May 26, 2021

**RE: MUSSEY GRADE ROAD ALLIANCE COMMENTS ON 2023-2025 WILDFIRE  
MITIGATION PLANS OF PG&E, SCE, AND SDG&E**

**Figure 1** – Diagram of SDG&E’s WiNGS Planning decision tree.<sup>41</sup>

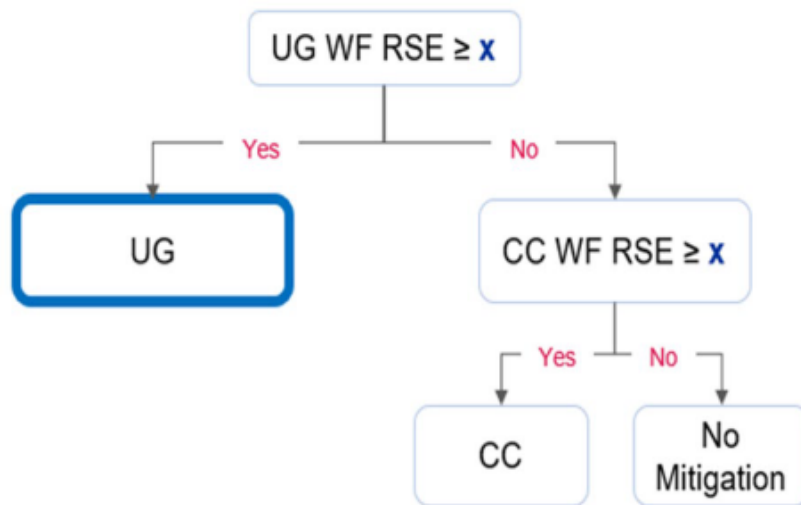
In this model, if the RSE is above a threshold value, then the undergrounding is planned for the circuit, and no comparison is done with covered conductor (the only other mitigation formally considered). Otherwise, covered conductor is chosen if it provides an RSE greater than the threshold value. SDG&E chose its threshold value in order to achieve an overall risk reduction of 83%.<sup>42</sup> Because this is higher than the claimed effectiveness of covered conductor, SDG&E's proposed solution would need to rely heavily on undergrounding in order to achieve this risk reduction level. Thus SDG&E automatically assigns higher risk circuits to be undergrounded, leaving those with lower risk to covered conductor, and thereby achieving a lower RSE for circuits mitigated with covered conductor.

**Figure 2** - Raw Technosylva simulation data was provided by SCE and PG&E in response to MGRA data requests, and the logarithm of maximum wildfire size for each set of 8-hour runs was accumulated into histograms.<sup>73</sup>

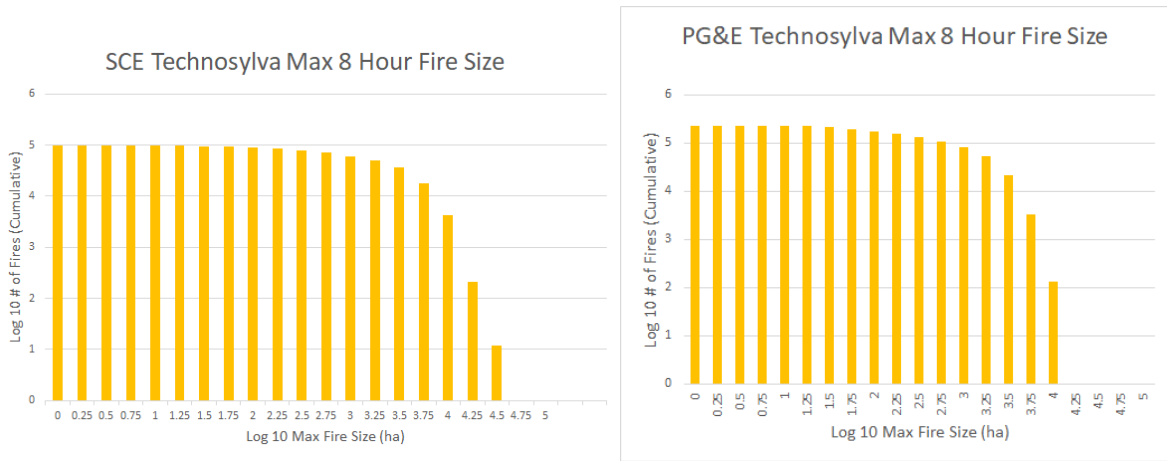
Actual wildfire size distributions follow a power law relationship over several orders of magnitude. The exponent of the cumulative power law distribution is smaller than one, meaning that the relative contribution increases with wildfire size, as shown below.

**Figure 3** - Total area burned per logarithmic bin for California wildfires 2005 to 2019, calculated by multiplying logarithmic mean of bin by number of wildfires in the bin. Power line related wildfires are compared against full sample with non-power line wildfires removed.<sup>74</sup>

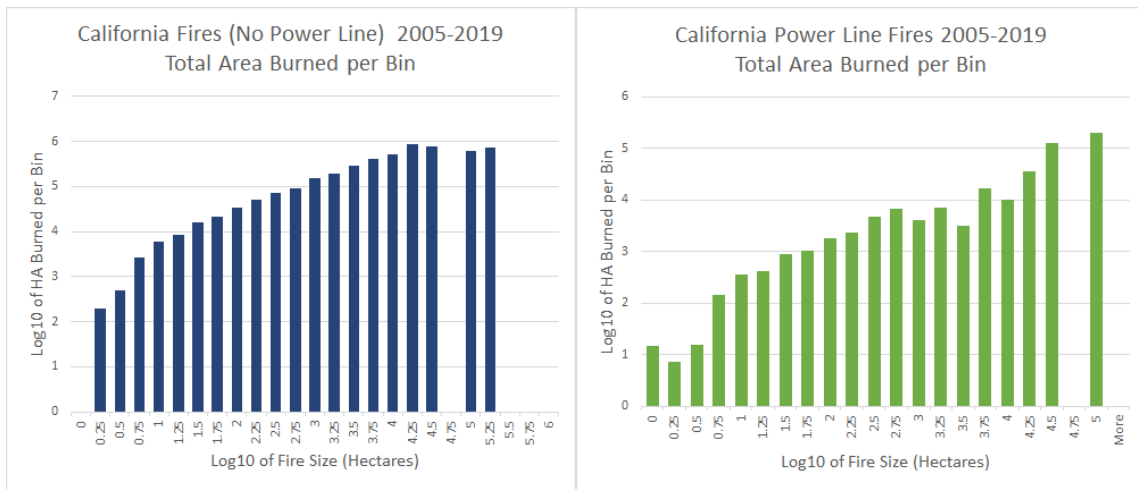
Figure 3 shows clearly why a truncated wildfire size distribution will fail to adequately represent consequences. Energy Safety has recognized these shortcomings and raised areas for improvement PG&E-22-05 and SDG&E-22-06 in its review of the 2022 WMPs.

**Figure 4** - SDG&E WiNGS v3 risk scores for overhead circuits, on a scale of green for lower risk to red for higher risk. Superimposed are the ignition points and final perimeters for the Witch/Guejito, Cedar, and Laguna fires.<sup>83</sup>

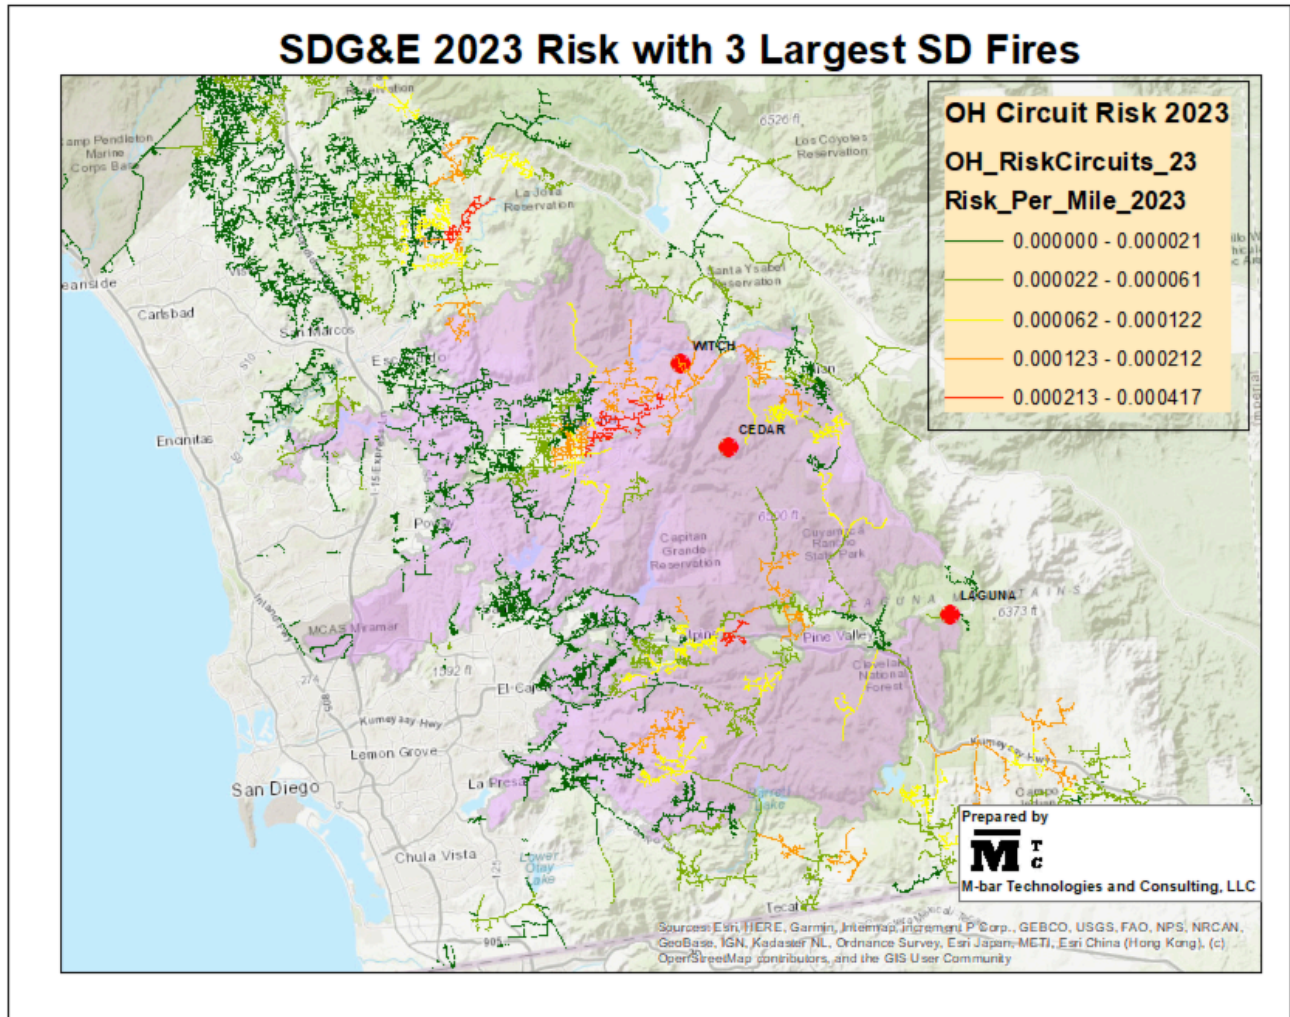
Figure 4 shows that the greatest circuit risk (in red) is predicted by SDG&E to be within and directly east of the population centers of Ramona, Alpine, and Valley Center. More remote areas tend to have lower relative risk. The ignition points for the Laguna, Cedar, and Witch/Guejito fires, however, can be seen to much further to the east of these areas. Circuits near these ignition points have relatively lower risk values. The losses from these three fires exceed all other historical San Diego County wildfire losses combined. These wildfires *are* the consequences for San Diego County for remote wildfire ignition.

**Figure 5** - SDG&E WiNGS v3 consequence scores for overhead circuits, on a scale of green for lower risk to red for higher risk. Superimposed are the ignition points and final perimeters for the Witch/Guejito, Cedar, and Laguna fires.<sup>84</sup>

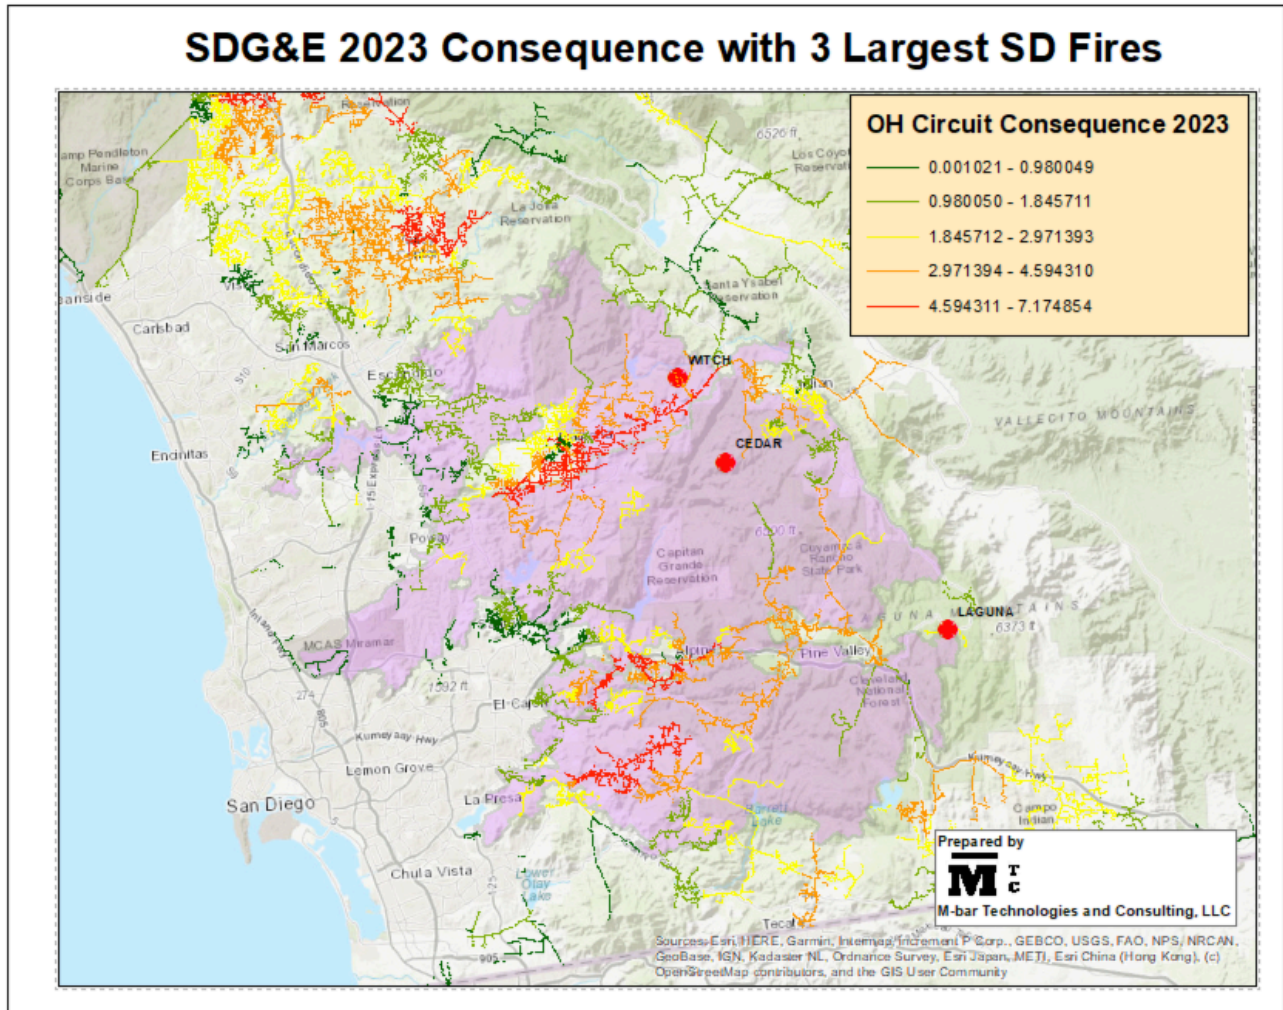
It is clear from Figure 5 that it is the consequence model, in other words the eight-hour run of Technosylva Wildfire Analyst, that is responsible for predicted risk being concentrated closer to population centers. While the Witch fire ignition point rates as very high consequence, circuits near the Cedar and Laguna ignition points do not. This is important because it will lead to incorrect prioritizations of wildfire risk mitigation. SDG&E's quality check on its result, comparing its circuits against those in coastal canyon areas,<sup>85</sup> is not an adequate validation of its model, since coastal circuits are not within the HFTD and are not high priority for SDG&E mitigation.

**Figure 6** - Ratio of SDG&E's 2023 risk score to its 2022 risk score. HFTD areas are shown in pastels.

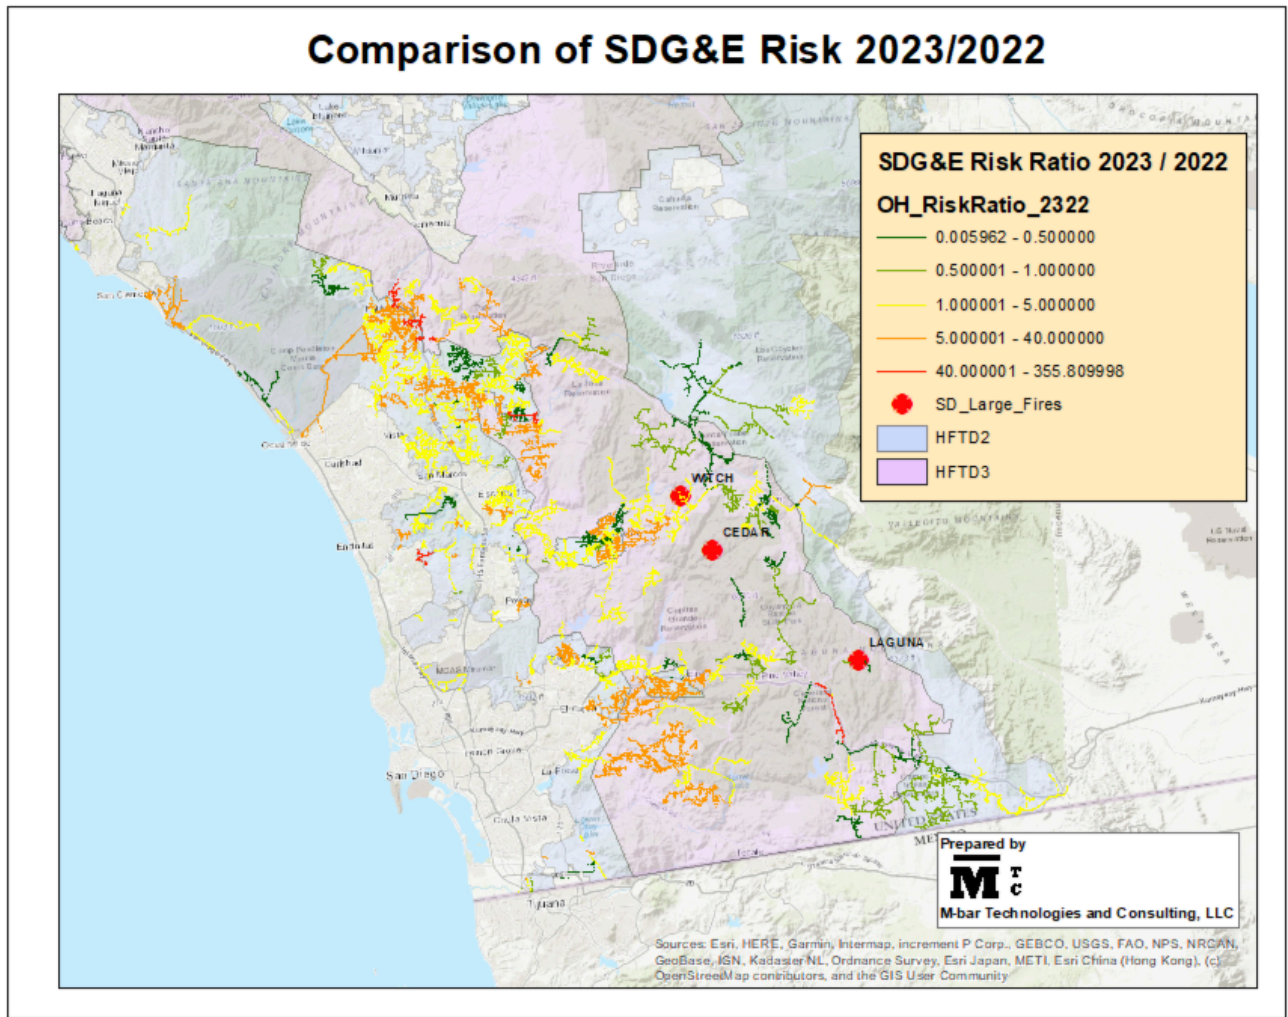
The interesting features in this map: 1) areas in and to the east of San Diego's mountains are seeing risk reduction, possibly due to SDG&E hardening efforts in these areas, 2) a net increase in risk values has been calculated 3) Largest risk increases in eastern canyon areas, particularly those proximate to and even in population centers.

**Figure 7** - Ratio of SDG&E's 2023 calculated ignition rate to its 2022 ignition rate.

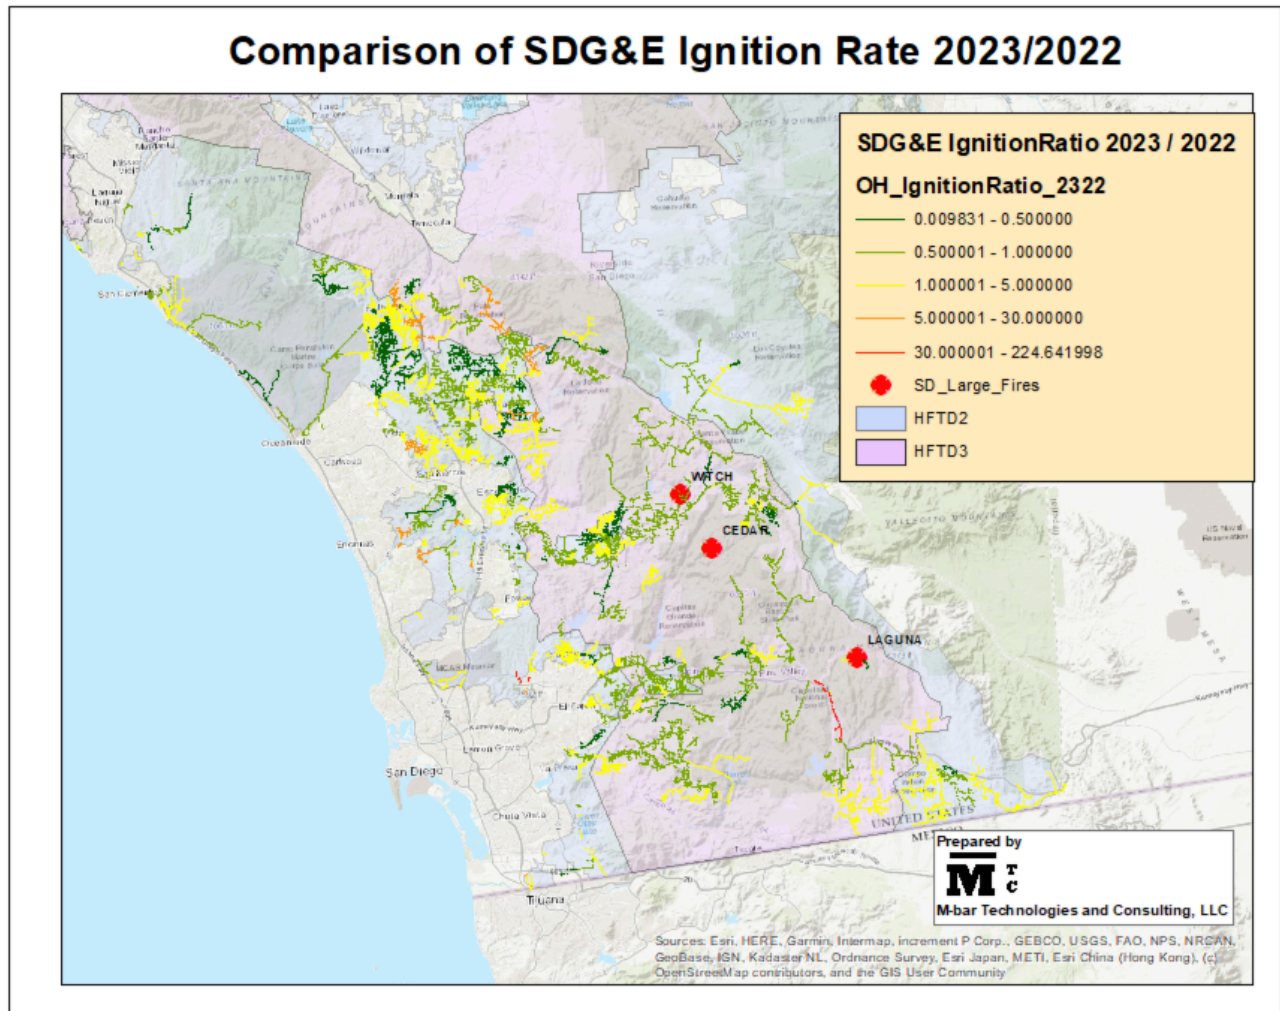
The results of this analysis are mixed, with the mountainous areas of San Diego generally seeing a decrease in ignition rate and the eastern margins of the HFTD seeing moderate increases. It is not obvious what would account for any trends.

**Figure 8** – Ratio of 2023 SDG&E Consequence scores to 2022 SDG&E Consequence scores.

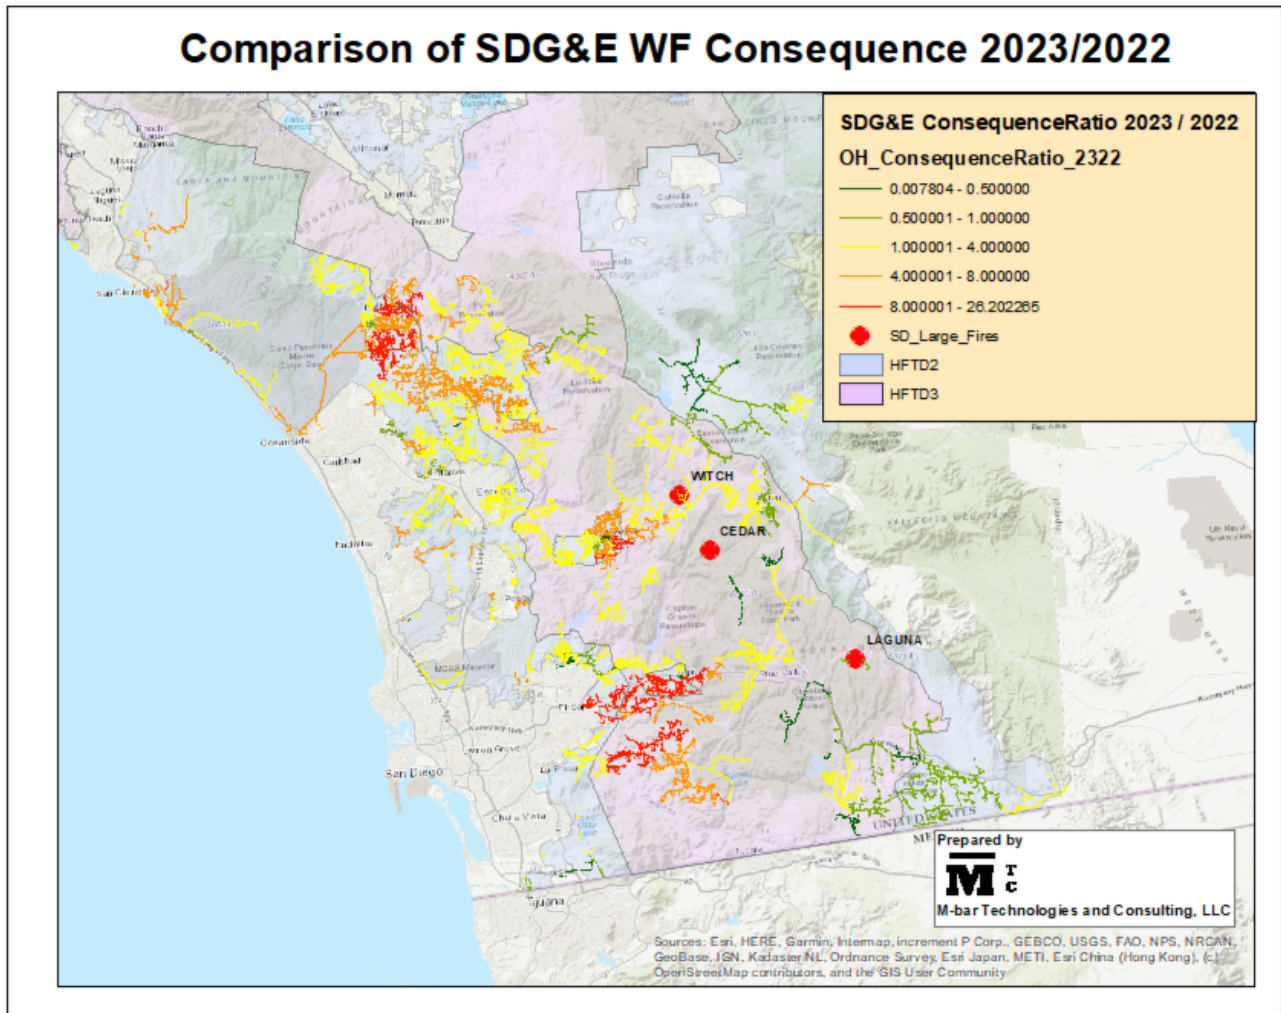
Figure 8 shows a dramatic difference increase in calculated consequences between the 2022 and 2023 risk models in most areas. A critical observation is that the most dramatic increases in consequence are centered around and in population centers: Fallbrook (to the northwest), Ramona (central), and Alpine/El Cajon (south). Decreases were only seen in the mountains and foothills, which were the sites of the three most damaging fires in San Diego County history.

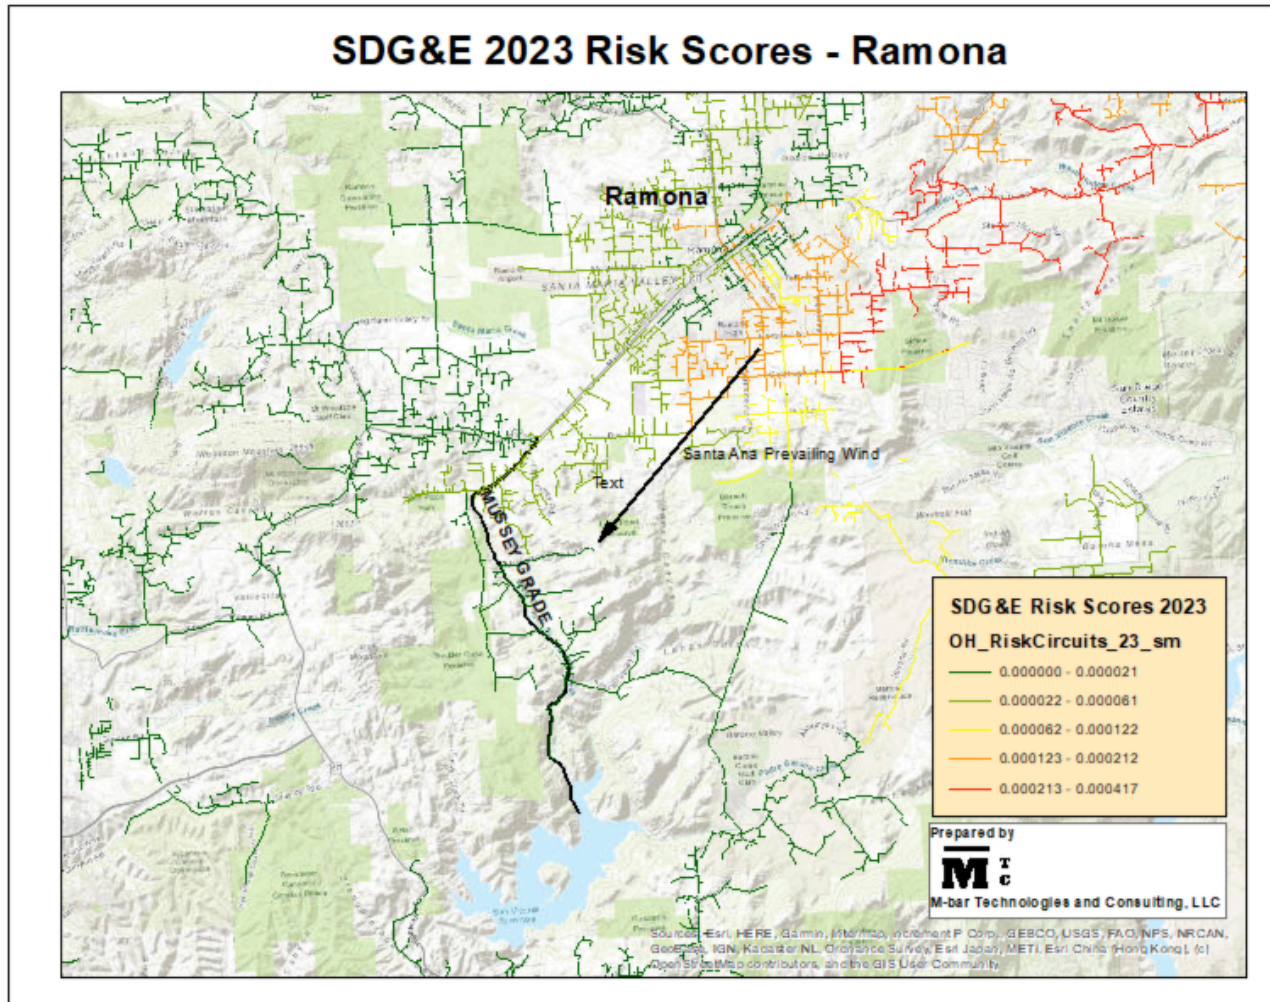
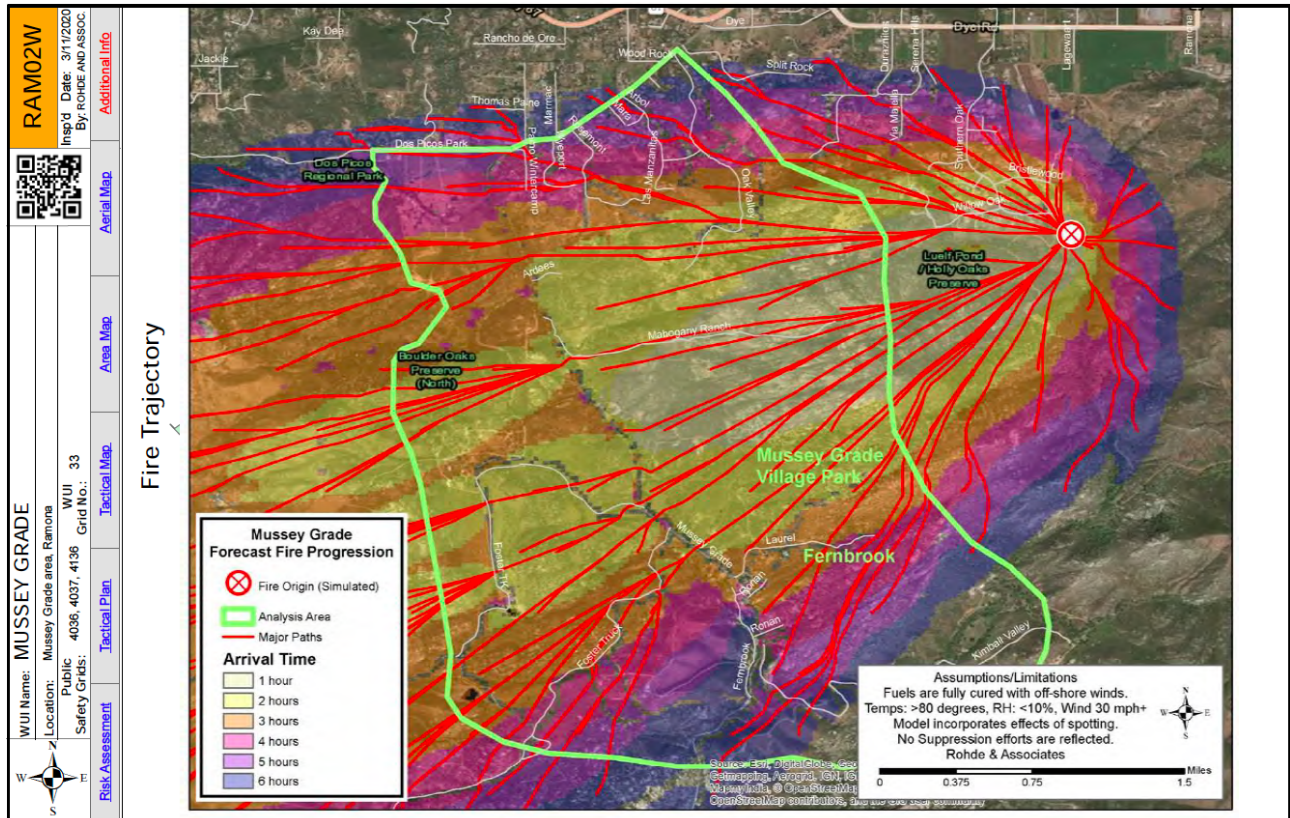
As is evident in Figure 10, an ignition in the area that SDG&E designates has elevated risk could reach the Mussey Grade Road corridor in as little as an hour. However, this model does not take smoke effects into account, which could severely limit visibility during evacuation. The inability of a community to evacuate could lead to a mass casualty event such as the Camp fire. This risk ultimately needs to be accurately reflected in consequence modeling.
